कार्यालय अधिशासी अभियन्ता,
निर्माण खण्ड, लोक निर्माण विभाग, रानीखेत

विषय :- कुनीगाड हिरुली बाजार से रामपुर चौखुटिया मोटर मार्ग के वन भूमि हस्तान्तरण के सम्बन्ध में। (प्रस्ताव सं. 8986/2014)

विषय :- कुनीगाड हिरुली बाजार से रामपुर चौखुटिया मोटर मार्ग के वन भूमि हस्तान्तरण के सम्बन्ध में। (प्रस्ताव सं. 8986/2014)

कार्य का नाम :- कुनीगाड हिरुली बाजार मोटर मार्ग का रामपुर चौखुटिया तक विस्तार मोटर मार्ग का निर्माण

जीयोरेफेरेन्स मैप - जनपद अल्मोड़ा के अन्तर्गत कुनीगाड़ हिस्सी बाजार मोटर मार्ग का रामपुर चौखुटिया तक विस्तार के निर्माण हेतु

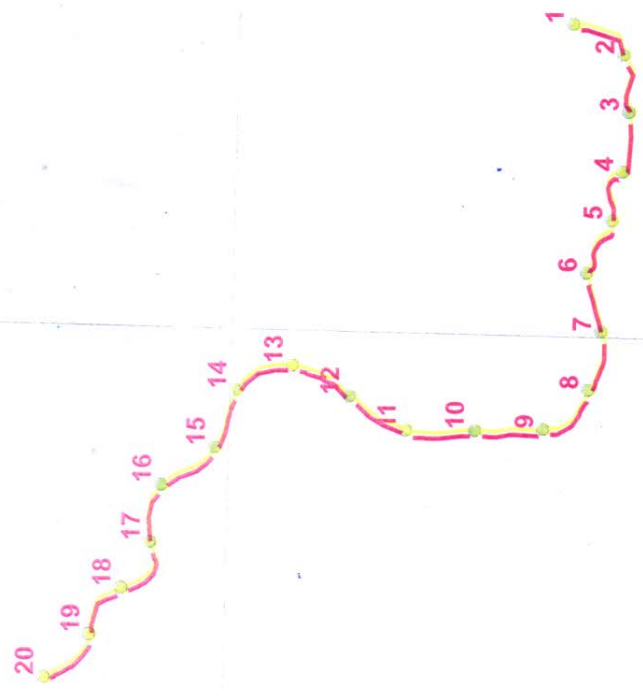
1	Digital map not proper as coordinates are written in hand. Proper digital map may provided.	Proper digital map with computerized coordinates is being attached . Part-1 para C-3
2	In the map end point is shown for away from Rampur.	.The Rampur Village is on the right side of the National Highway (shown as red colour) in the digital map. The portion of the road from the end point of the proposed road upto the National Highway near Rampur has already been constructed which is shown as black colour in digital map. The revised digital map is being attached as in point no.-1
3	No titles given to thee document provided in the list of additional documents in part I.	Titles given to the documents has been incorporated in the list of additional documents in part-1 Sl. No. 1 to
4	Forest land proposed for diversion shown as Van panchayat land in joint inspection report whereas shown PF in part II	
5	In Ca land map coordinates are provided for one point only whereas CA land being more than 1 ha coordinates at minimum 4 points are required.	Digital map for C.A. consisting coordinates of 4 points is being attached. Part-1 para L-13

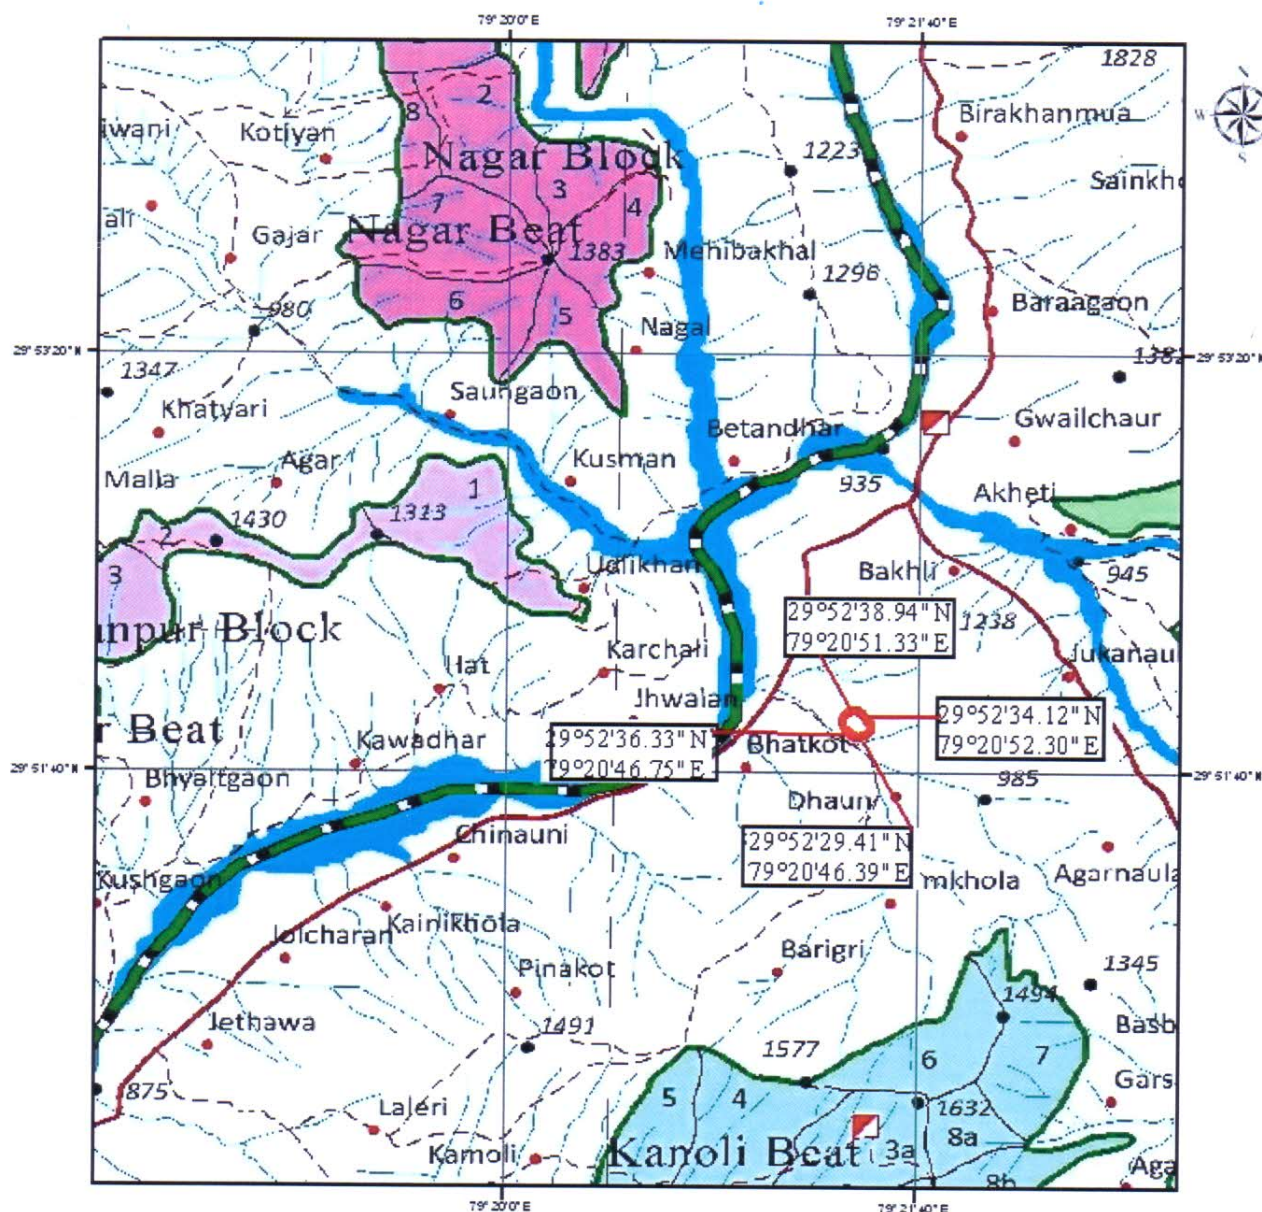
1	Digital map not proper as coordinates are written in hand. Proper digital map may provided.	Proper digital map with computerized coordinates is being attached .
2	In the map end point is shown for away from Rampur.	.The Rampur Village is on the right side of the National Highway (shown as red colour) in the digital map. The portion of the road from the end point of the proposed road upto the National Highway near Rampur has already been constructed which is shown as black colour in digital map. The revised digital map is being attached as in point no.-1
3	No titles given to thee document provided in the list of additional documents in part I.	Titles given to the documents has been incorporated in the list of additional documents in part-1
4	Forest land proposed for diversion shown as Van panchayat land in joint inspection report whereas shown PF in part II	
5	In Ca land map coordinates are provided for one point only whereas CA land being more than 1 ha coordinates at minimum 4 points are required.	Digital map for C.A. consisting coordinates of 4 points is being attached.
